UNITED STATES
 NUCLEAR REGULATORY COMMISSION
 REGION II
 101 MARIETTA STREET, N.W., SUITE 2900
 ATLANTA, GEORGIA 30323

Report No.: 50-302/92-11

Facility Name: Crystal River 3

This special announced inspection was conducted to review the circumstances involving the failure of Emergency Feedwater valve EFV-14 to close completely during a differential pressure test performed on October 15, 1991, as recommended by Generic Letter, GL 89-10, "Safety-Related Motor Operated Valves Testing and Surveillance."

FIGURE 1. CRYSTAL RIVER UNIT 3 EMERGENCY FEEDWATER SYSTEM

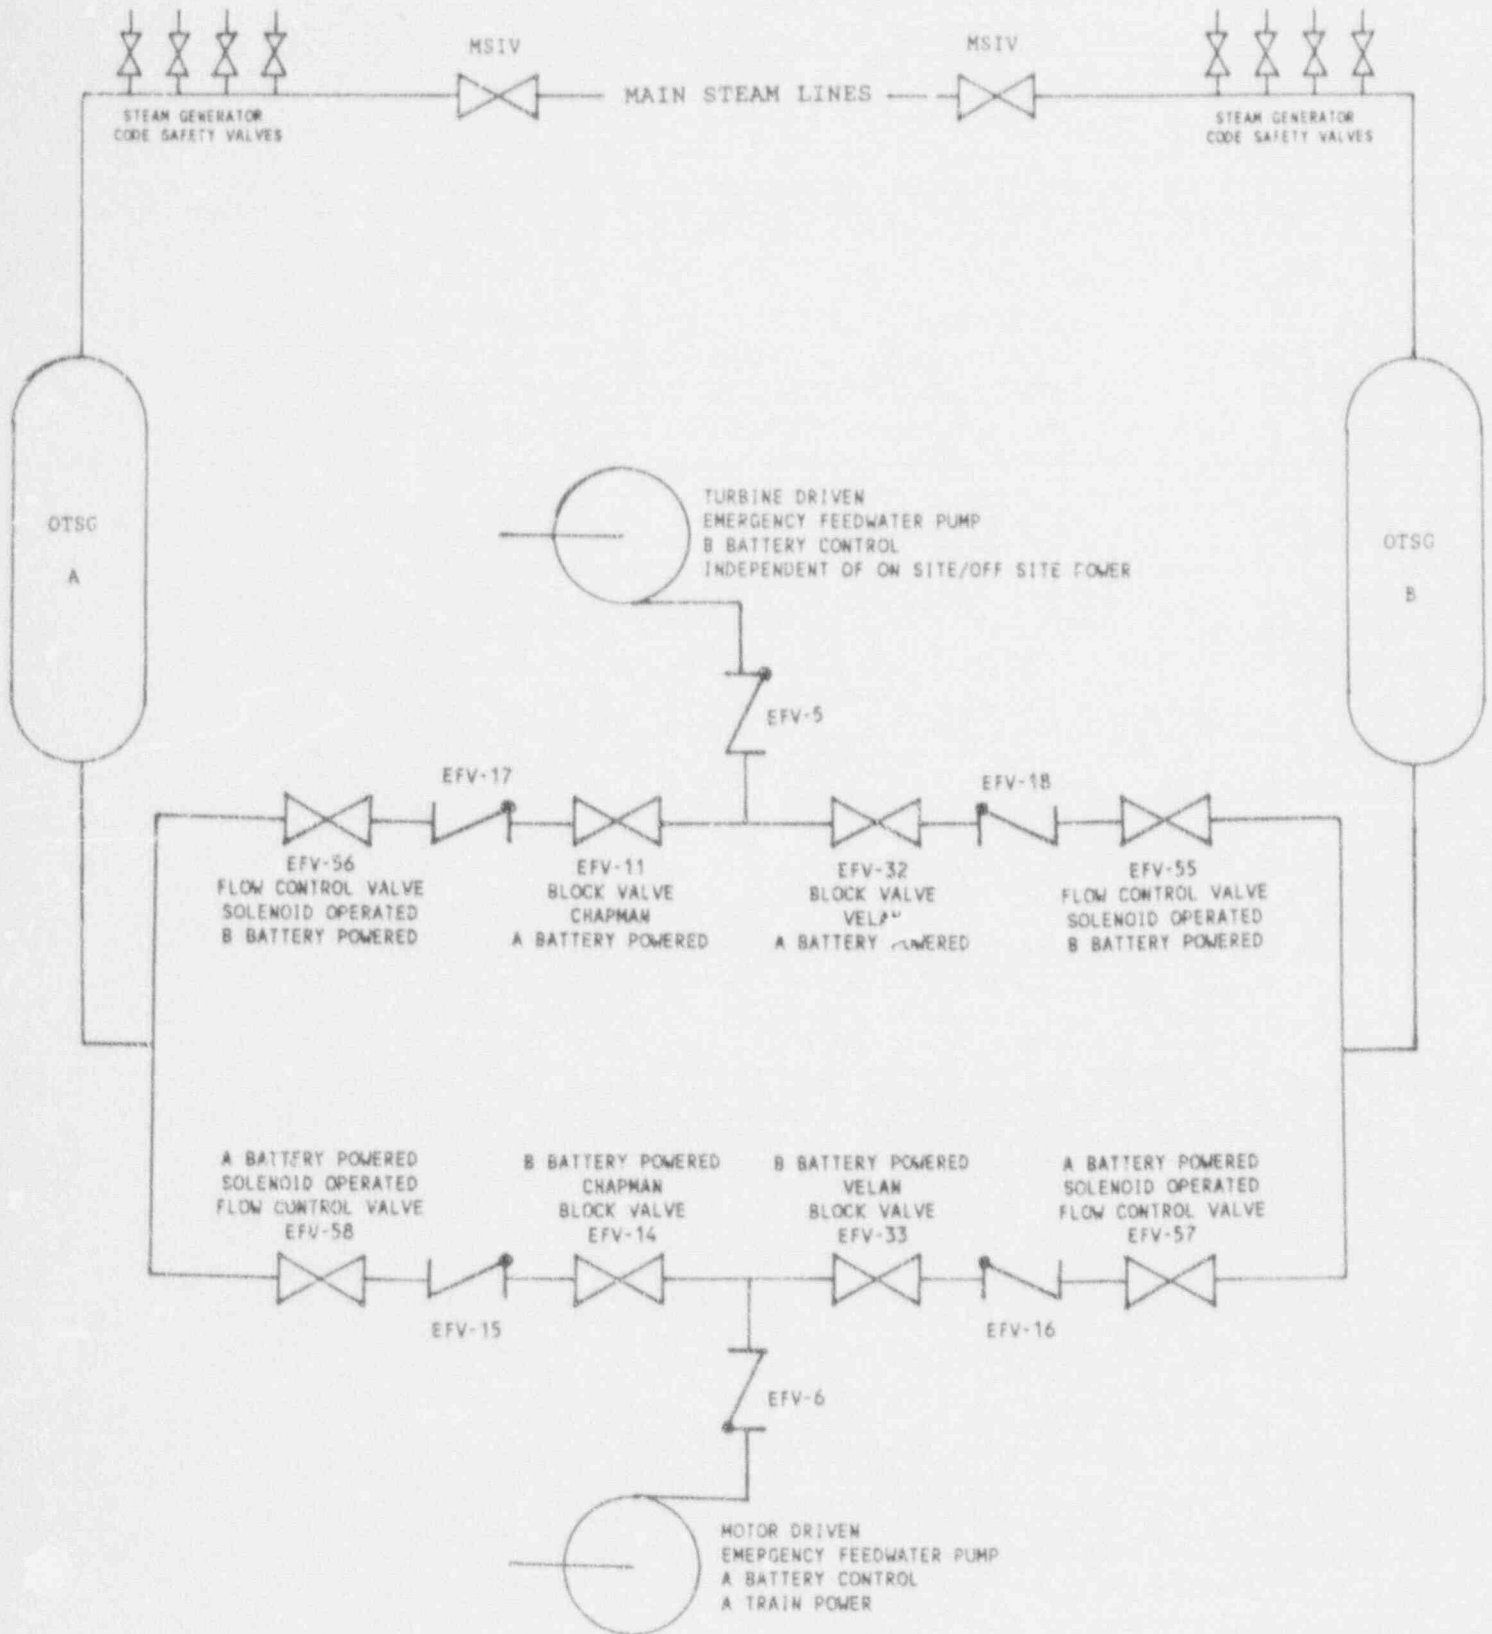
The emergency feedwater system, EFS, consists of two full capacity, independent systems, which includes two pumps and associated valves and piping. (See Figure 1) The system automatically supplies emergency feedwater to one or both steam generators, OTSG, to provide decay heat removal for normal reactor cooldown and a number of analyzed events.
